**Project Name:** 142 S. Ocean Boulevard - Sandoway Discovery Center (2021-033)

**Request:** Class II Site Plan Modification and Certificate of Appropriateness

## HISTORIC PRESERVATION BOARD STAFF REPORT

### 142 South Ocean Boulevard

**touch tank**  
**detail**

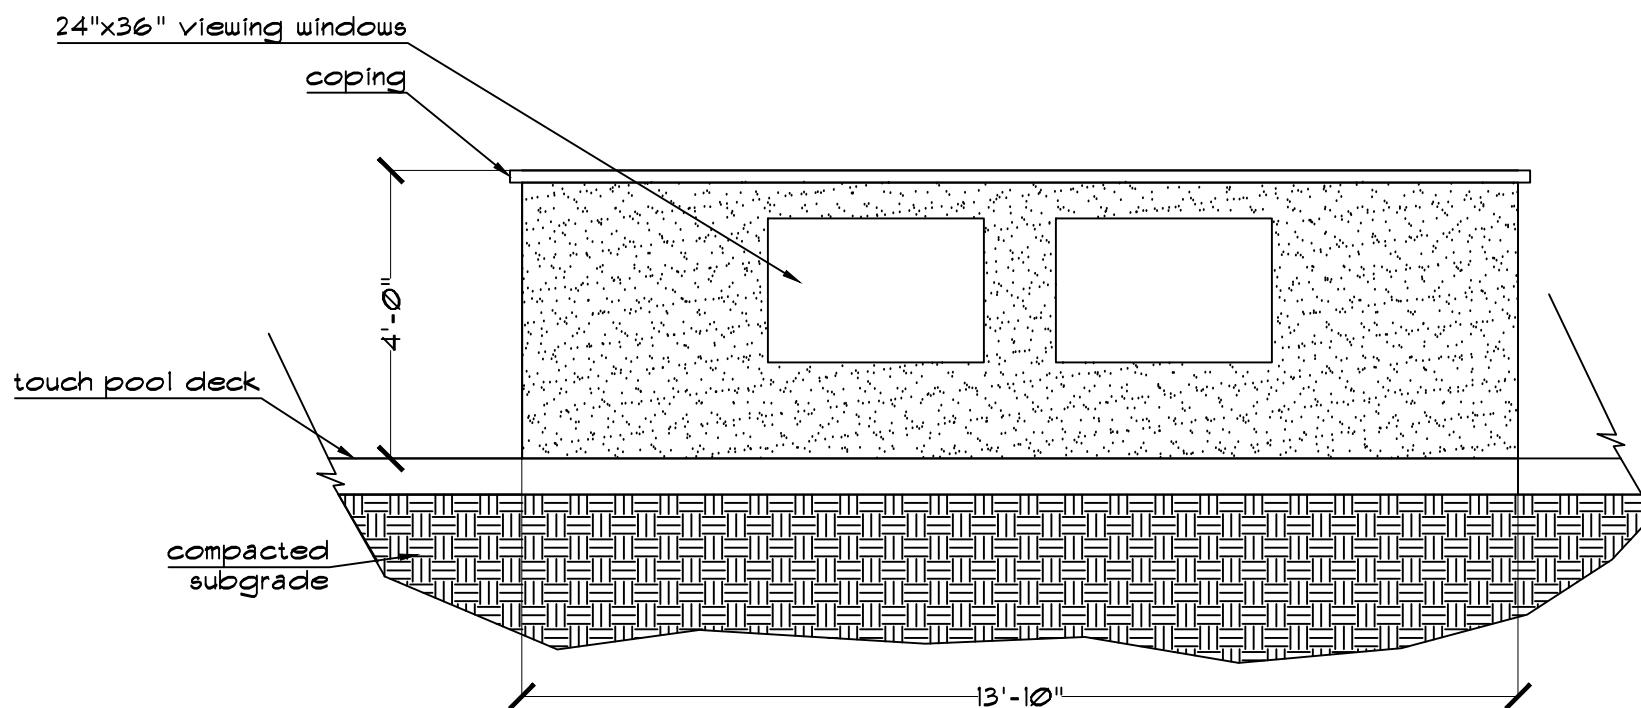
The subject proposal includes the installation of a new 4' touch tank and canopy to the rear (northwest) side of the property. The proposed touch tank and canopy will adhere to the required setbacks and the required perimeter setback area is currently landscaped. It is also noted that a concrete block wall exists along the western property line, meeting the requirements for buffering and aesthetic purposes and the proposed improvements are setback at least 10' from the west property line and 10' from the north property line. It is noted the paved walkway that surrounds the tank is setback 5' from the property line. Currently, the walkway is situated immediately adjacent to the property line, and the proposal includes revision of the walkway layout to provide the 5' setback with landscaped area.

A 4' touch tank is proposed in the rear (northwest) side of the property and will meet the requirements of this code section as the existing, as well as the proposed touch tanks are enclosed with protective fencing.

The subject property has an existing 4' masonry wall located on the rear (west) and side (south) end of the property. In addition, there is an existing partition that will be removed which currently separates the existing touch tank with the one being proposed. The new touch tank will have a 4' PVC fence around the north side of the structure. Non-historic and/or synthetic materials are discouraged; therefore, an added condition of approval is that any and all proposed fencing material be authentic such as wood, masonry, or aluminum.

1. That any and all proposed fencing material be authentic such as wood, masonry, or aluminum.
- D. Deny Class II Site Plan Modification and Certificate of Appropriateness (2021-033), requests for the property located at **142 S. Ocean Boulevard, Individually Listed to the National Register of Historic Places**, by finding that the request is inconsistent with the Comprehensive Plan and does not meet the criteria set forth in the Land Development Regulations.
